**FINAL INITIAL STUDY/
MITIGATED NEGATIVE DECLARATION**

10 MAY 2000

OAKLAND TELECOMMUNICATIONS ACCESS BUILDING

Oakland, California

Figure 2

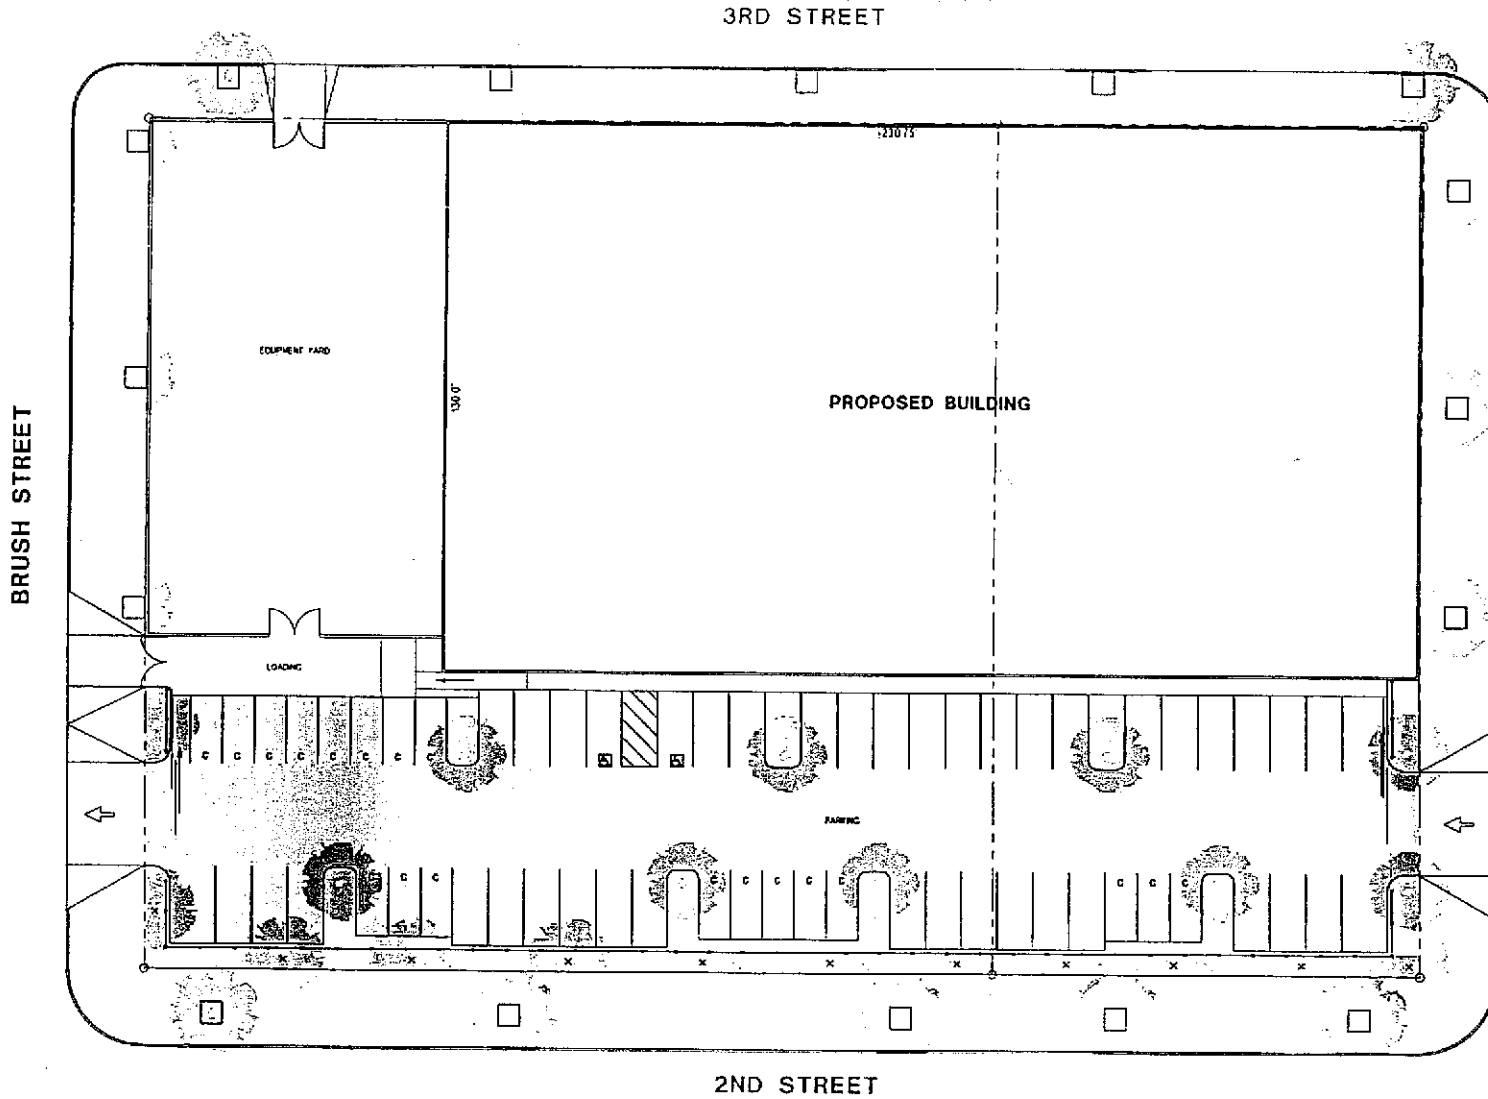
The commentor states that the proposed project's floor area ratio (FAR) exceeds the maximum 2.0 FAR permitted in the Light Industrial District. The commentor cites a section of the City of Oakland's "Guidelines for Determining Project Conformity with the General Plan and Zoning Regulations."

The commentor states that the project exceeds the maximum floor area ratio (FAR) permitted under the *Estuary Policy Plan*. The commentor states that the City of Oakland Land Use and Transportation Element (LUTE) and "Guidelines for Determining Conformity with the General Plan and Zoning Ordinance" do not include an exemption for off-street parking in calculating FAR. The

The proposed building is located on a 60,000-square foot lot, and has been designed to comply with the FAR limit of 2.0. The proposed structure, as described in the Modified Project Description, consists of 119,990 gross square feet. Thus, the floor area ratio (FAR) of the building would be 2.0 (119,990 square feet divided by the lot size of 60,000 square feet). Each typical floor of the building consists of 29,997 gross square feet (see "Project FAR Statistics" table in Figure 2 of the Modified Project Description, above).

With the design modifications to the building, including elimination of the first floor covered parking, the building FAR is 2.0, which is consistent with the *Estuary Policy Plan's* requirement.

Figure 7

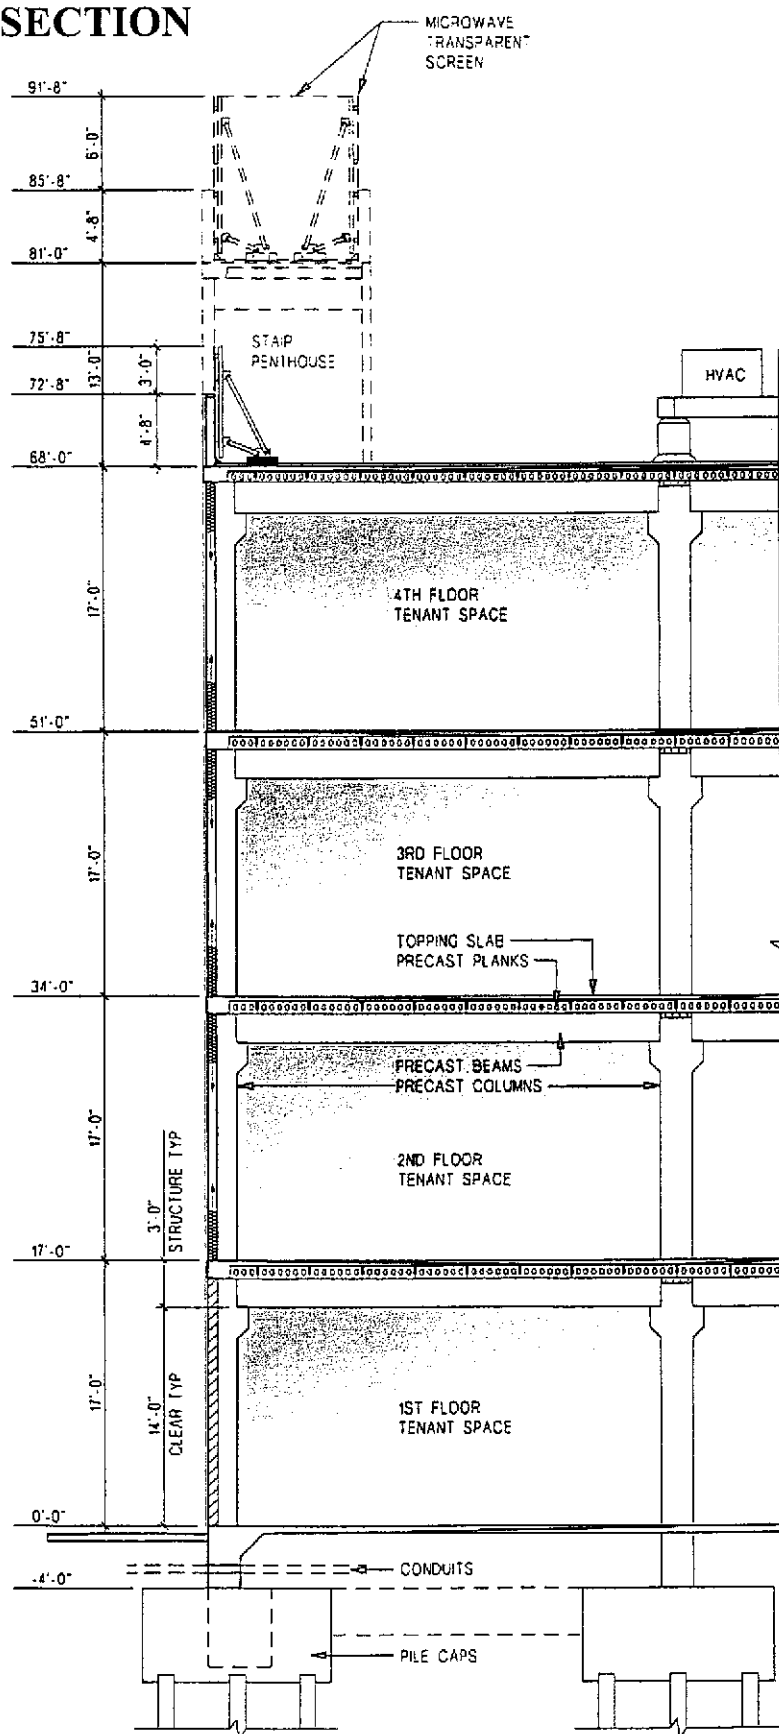
The commentor states that the Project Description is misleading in referring to the proposed building as a four-story building, because a 76-foot building is equivalent to a seven story building like the Port Building at 530 Water Street.

The commentor states that the elevation drawing indicates a height of 67 ½ feet for the building and the text indicates 70 feet.

As noted above in Section I, Modified Project Description and Errata, the telecommunications building was originally proposed as a four-story structure, with parking to be located on the first floor. In response to comments received, the architectural plans have been modified to remove the parking from the first floor and replace it as surface parking along Second Street. The building footprint has been reduced by 40 feet in length. Instead of parking, the first floor of the building would be occupied by electrical equipment and tenant space. The height of the modified building would be slightly increased because the first floor parking, with a ceiling height of 13 feet, would be replaced with tenant space, which requires a ceiling height of 17 feet. The height of the building, measured from ground elevation to the top of roof plane is 68 feet and the top of the parapet screen is 75 feet 8 inches (Figure 7).

As noted above in Response B-2, the final revised architectural drawings for the proposed telecommunications building indicates a height of 68 feet to the roof plane and 75 feet 8 inches to the top of the parapet screen (Figure 7). There are no height limitations associated with this project.

Figure 8

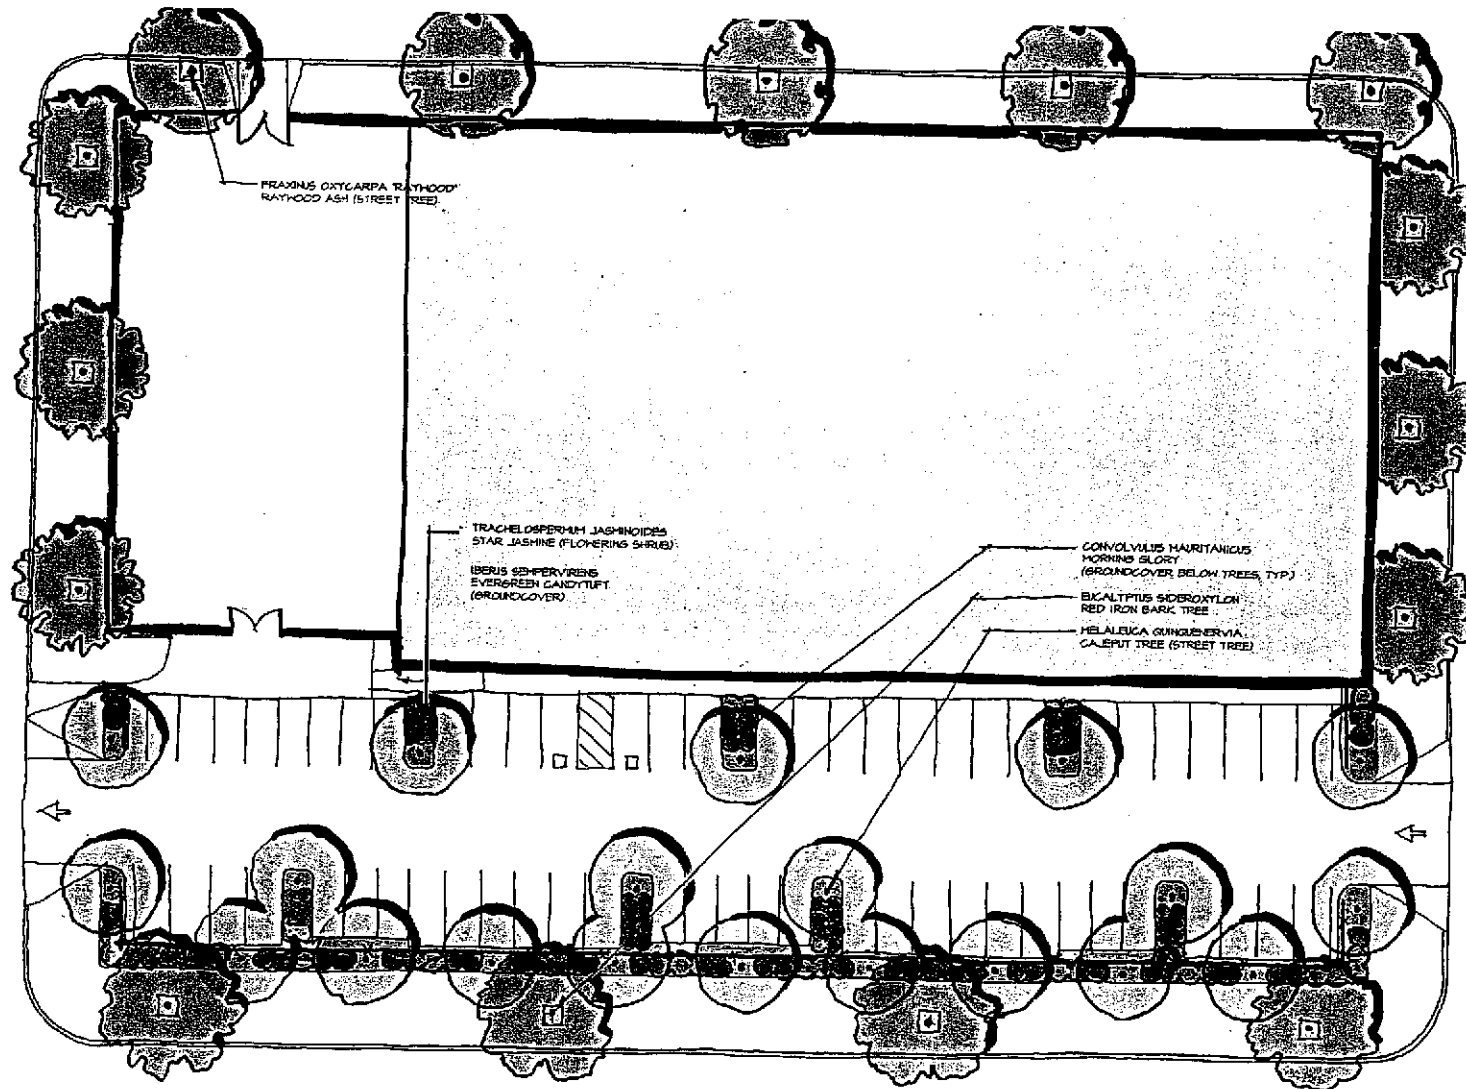
The commentor has raised issues regarding potential impacts of the new building on views from the proposed Phoenix Loft work-live project now under construction across Second Street. In response to the comments, which were submitted based on the original Initial Study dated March 14, 2000, additional visual/aesthetic analysis was included in the Revised Initial Study.

The commentor proposes that a more sensitive and less hard-edged building design be adopted.

As shown in the Modified Project Description, the developer of the proposed project has augmented the landscaping plans along Second Street by installing more trees, which would help to soften the visual treatment of the building seen from the work-live units (Figure 8).

The developer has added landscaping along Second Street to soften that edge of the building (Figure 8 in the Modified Project Description).
